***Coordinated Development District Conceptual Design Plan
#2021-00002***

Development Special Use Permit #2021-10019

***Eisenhower East Block 32 / Carlyle Plaza Two Amendment
– 760 John Carlyle Street, 1700 & 1800 Eisenhower
Avenue, 800 Bartholomew Street***

SUBJECT: INFORMATION FOR DOCKET ITEM #11 – Development Special Use Permit #2021-10019 - 760 John Carlyle Street, 1700 & 1800 Eisenhower Avenue, 800 Bartholomew Street - Eisenhower East Block 32 / Carlyle Plaza Two Amendment

Figure 15. Areas Where a Street Tree Modification is Acceptable (in pink)

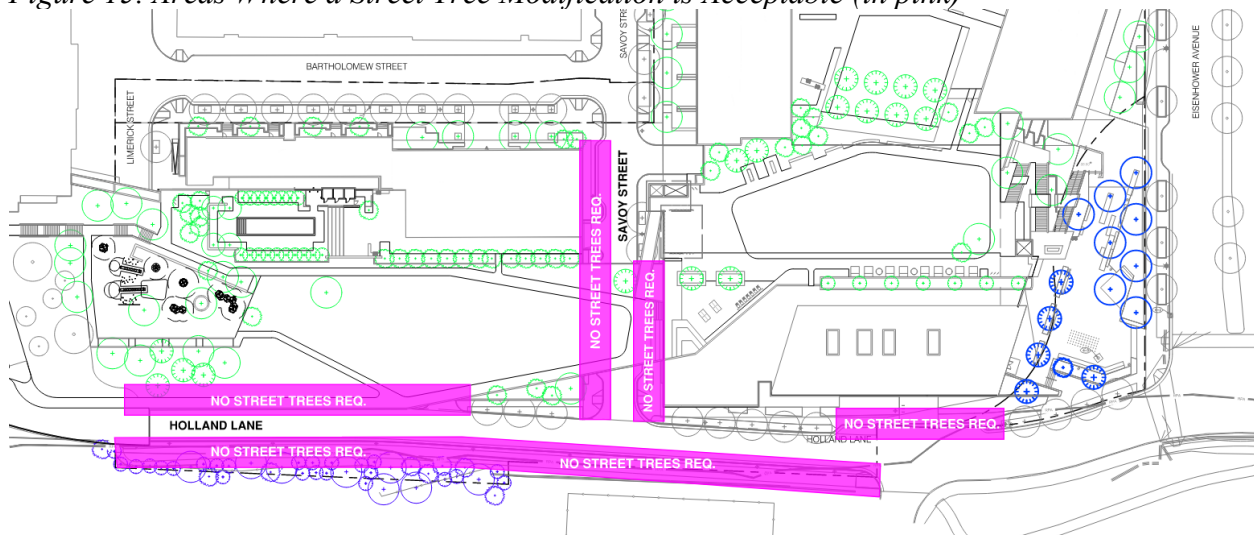
The applicant is requesting a modification to the street tree requirements outlined in the 2019 Landscape Guidelines. Per the guidelines, projects that require a Development Special Use Permit (DSUP) approval require one street tree for every thirty (30) feet of lot frontage along the public right of way, with a minimum of one per frontage. The applicant is not meeting this requirement for areas along Savoy Street and Holland Lane due to confined street sections along Holland Lane and underground utilities and the unsupportive growing environment created by the open space bridge above Savoy Street. The applicant is requesting a reduction of the total street trees for the areas not including street trees as shown on the Preliminary Plans and highlighted in Figure 15, below. Staff would like the applicant to provide street trees on Savoy Street, if possible, and has included Condition #12h, which states that “the applicant shall work with City Staff to provide additional street tree plantings where feasible”. The applicant is meeting the required 25% minimum canopy coverage requirement by providing 42% canopy coverage on the property.

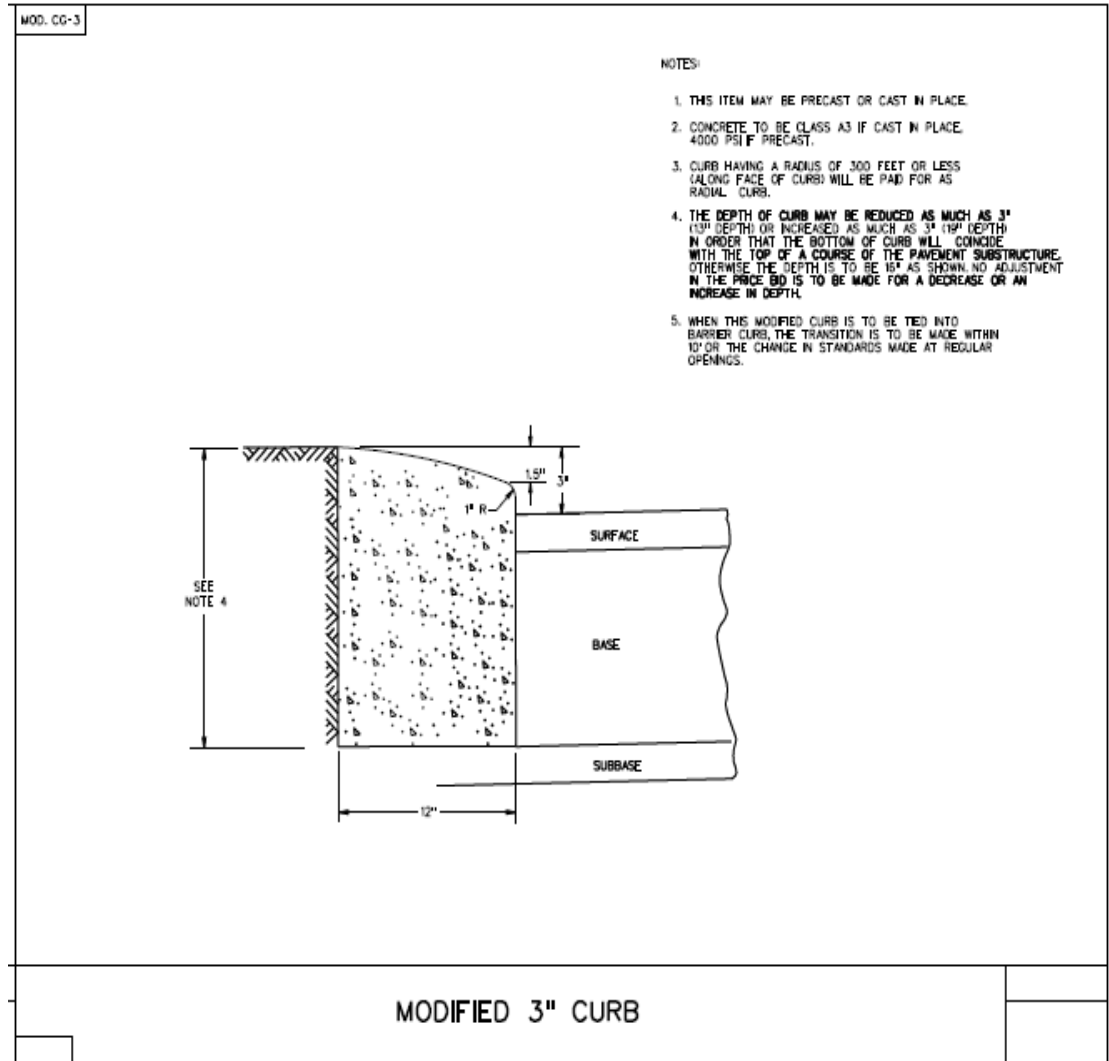
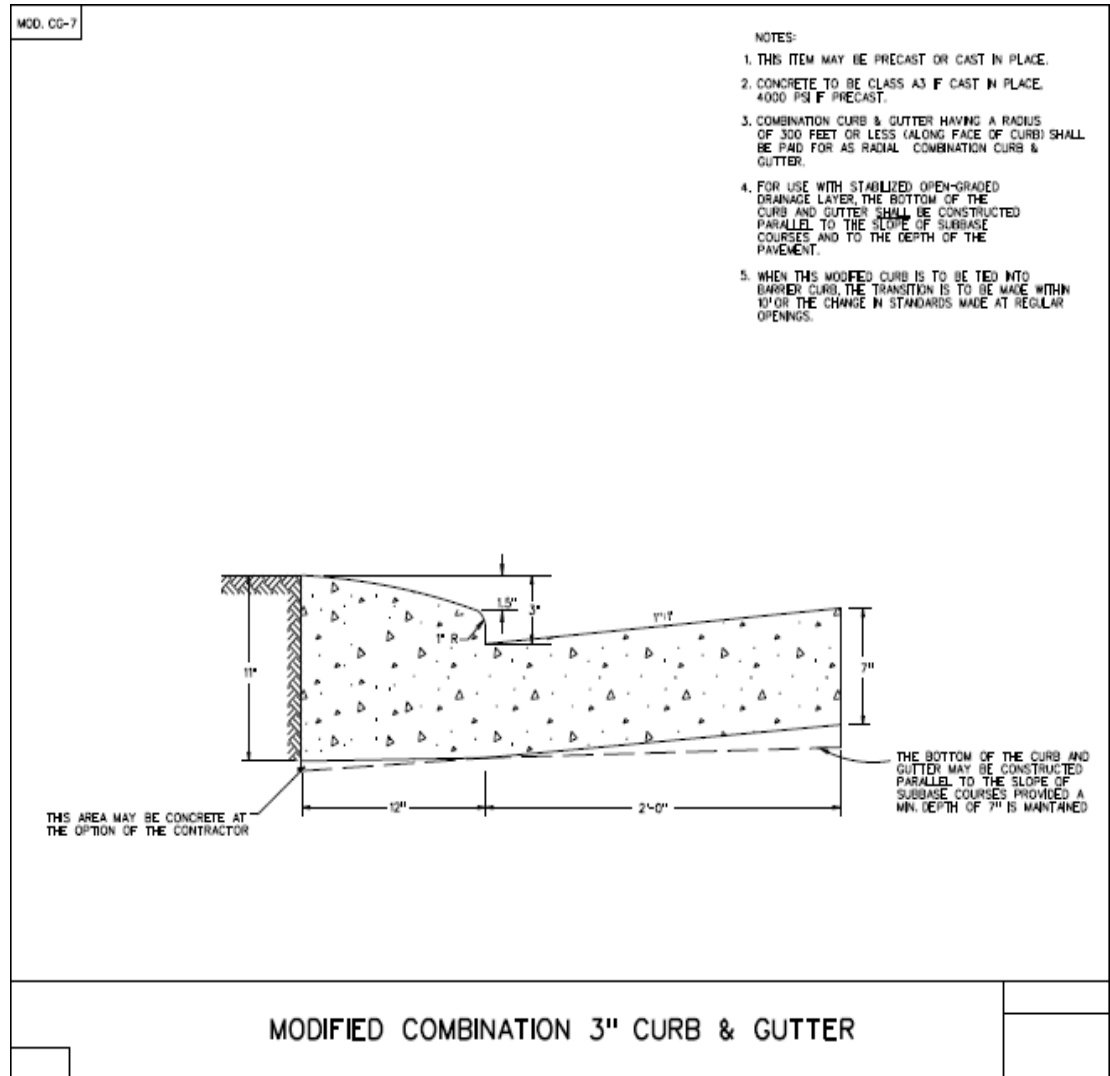
C - 7 CODE REQUIREMENT AMENDED BY STAFF (DSUP2019-0024): The fire service plan shall show placement of emergency vehicle easement signs. See sign detail and placement requirements are as follows.

Emergency vehicle easements shall be a minimum of 22 feet across the travel lane. The emergency vehicle easement shall provide access to strategic areas of the building and fire protection systems. Curbing and street components shall conform

Where curbing is a component of the emergency vehicle easement, the curbing construction shall conform to weight and grade requirements for vehicular traffic. In no circumstances shall a raised curb be located in the path of travel in an emergency vehicle easement. Where a mountable curb is provided as part of an emergency vehicle easement, emergency vehicle easement signs shall be posted at the point nearest the edge of the emergency vehicle easement, but in no case within the clear width of the emergency vehicle easement. With the exception of flush curbs, any fire department access points that require fire apparatus to mount a curb shall conform to the modified 3 inch curb design standard MOD CG-3 or MOD CG-7 design as shown.

EVE's are proposed in sign locations have been added to drawings.

Revised Phasing Diagram

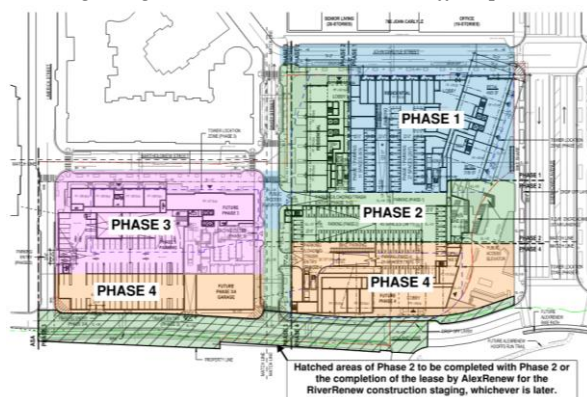
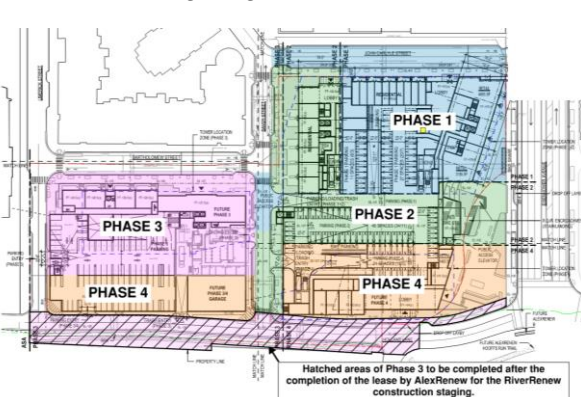
Staff has updated the proposed phasing diagram in Figure #3a “General Phasing” and Attachment #4 to reflect recent discussions with the applicant. Staff and the applicant have agreed that the construction of Holland Lane and the Holland Lane bike trail may be provided with either Phase 3 or Phase 4 of construction, whichever comes first.

- Revised Condition #6c to read as follows:
#6c: Construct the Holland Lane off-street bike/pedestrian trail **with Phase 3 or 4, whichever comes first** and ~~landing plaza at the end of Eisenhower Avenue~~. The construction shall not prevent traffic flow through the intersection of Eisenhower Avenue and Holland Lane.***

Attachment 2B. Proposed Max. Building Footprints

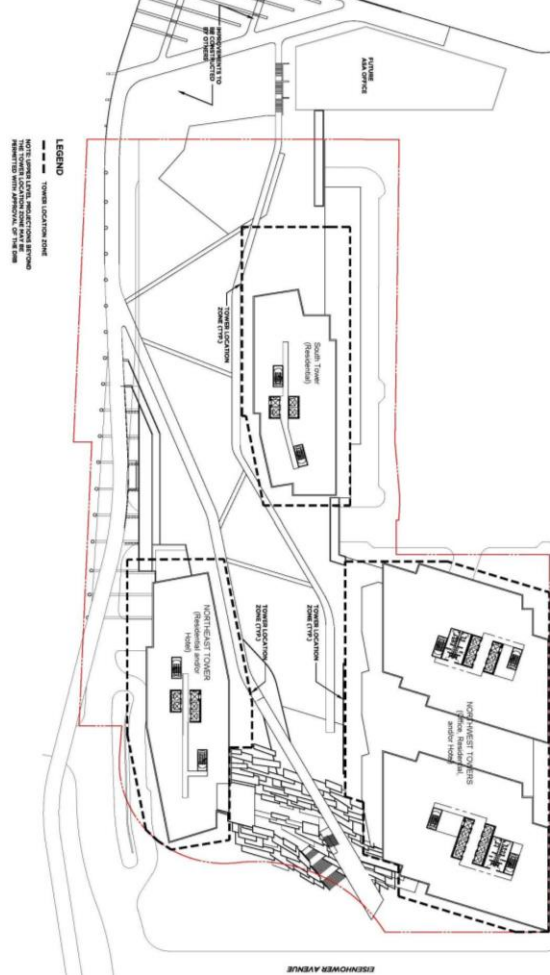
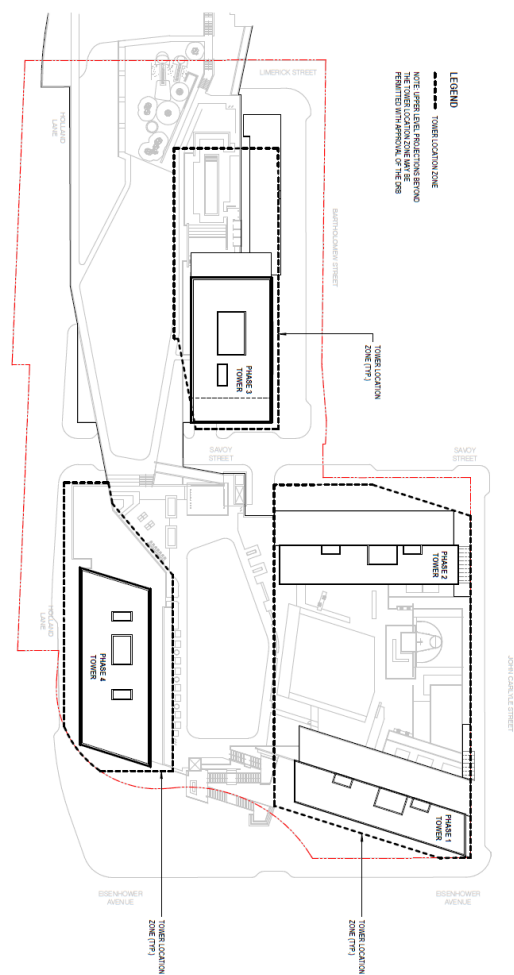
The applicant has modified the maximum footprint diagram approved with DSUP #2013-0025 to accommodate the building footprints proposed with this amendment. The Phase 1 tower footprint requires a minor adjustment to remove a jog in the line to accommodate the design proposed. Further, the Phase 4 tower footprint has been reduced to accommodate the expansion of the open space deck. The Phase 2 and Phase 3 tower footprints remain unchanged. Staff has therefore added Attachment 2B to the staff report to illustrate the revised footprints and has made changes to condition #11 and #34 to reference the correct attachment.
